**MONTEREY PENINSULA
WATER MANAGEMENT DISTRICT**

June 24, 2002

**Subject: Monterra Ranch Water Company – Annual Water Monitoring Program
Report for Reporting Year 2001**

Figure II-8

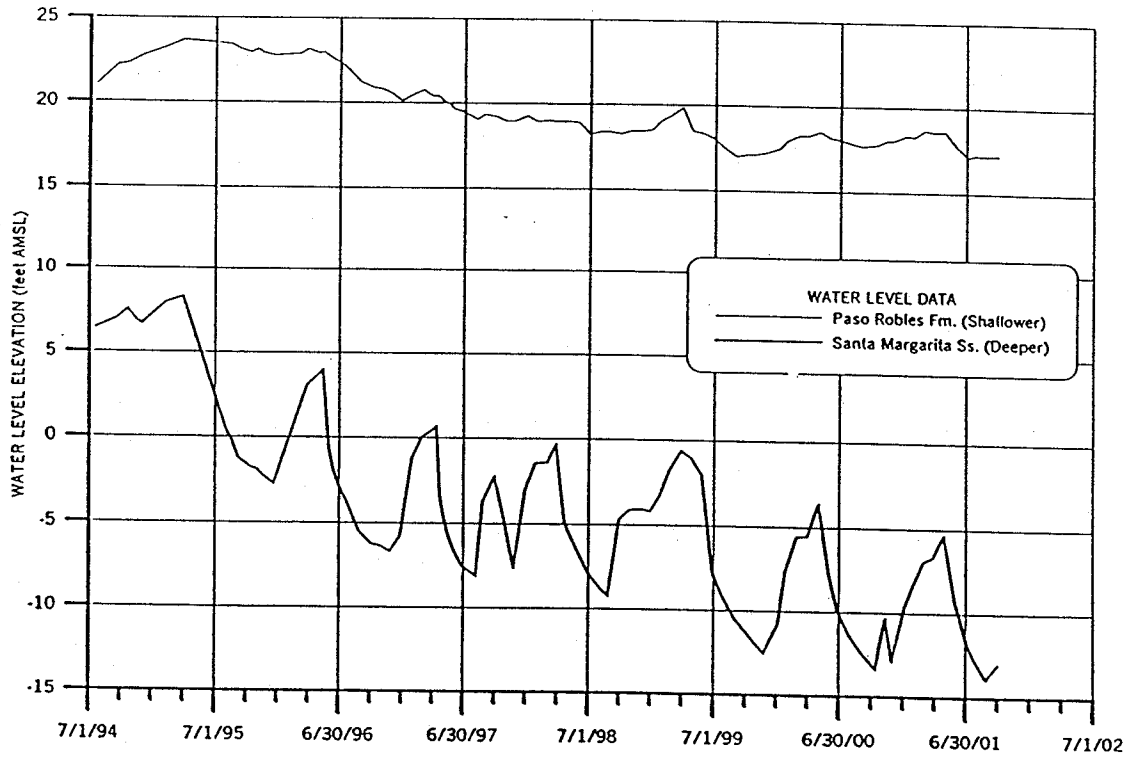
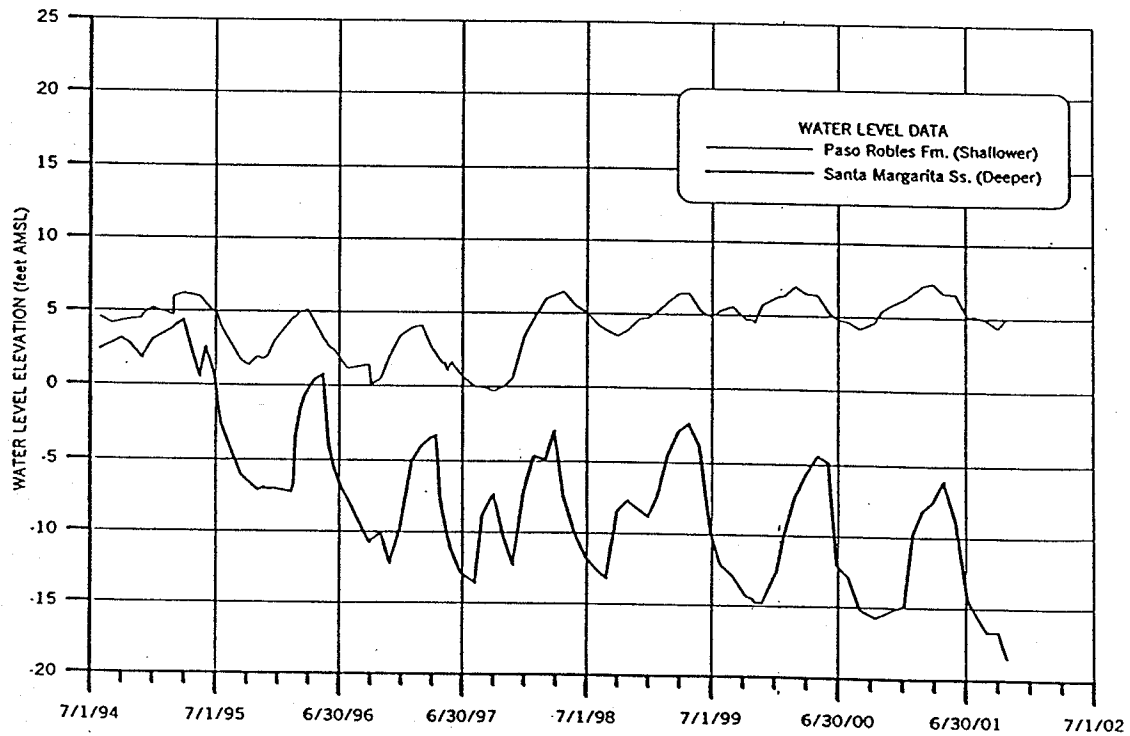
Most importantly, the water-level elevations for each well from each *Annual Report* and from previous reports should be plotted to discern long-term trends in water levels. Historical water-level elevations for a number of the wells on the Monterra Ranch property have been previously provided to the system operator (**Enclosure 3**). An example of this type of plot is included as **Enclosure 4**.

Boronda Road Well
T16S/R2E-33Q1

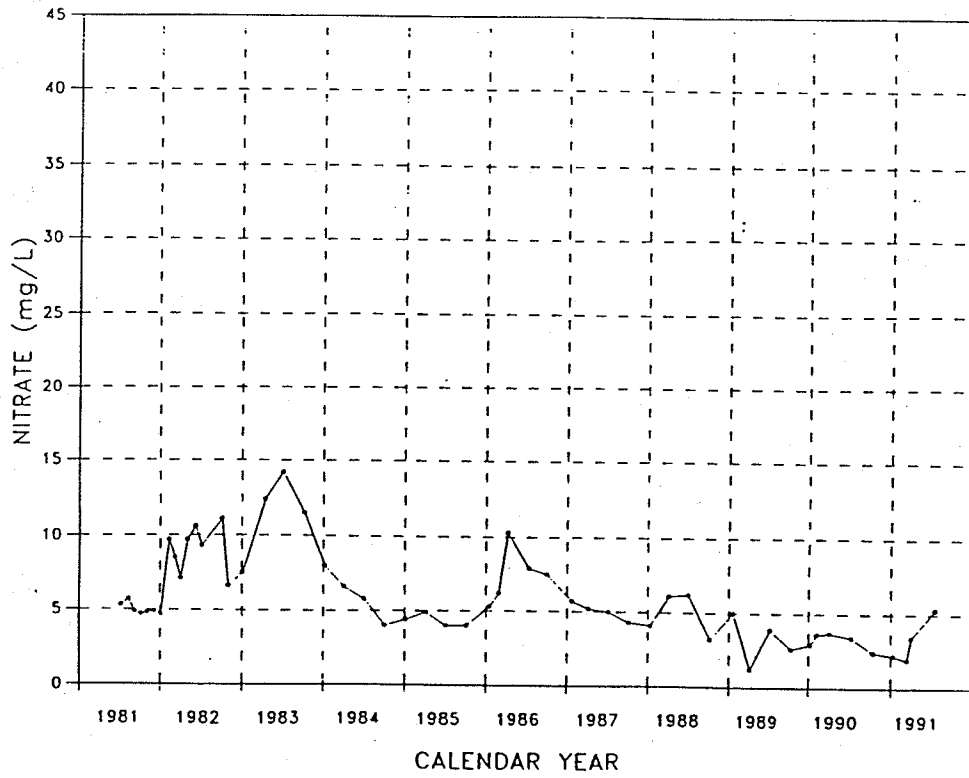
Ground Water Quality Trends. Similar to the time series plots recommended for water production and levels above, current and historical water quality data should be plotted to detect any significant trends. A sample of this type of plot is included as **Enclosure 5**.
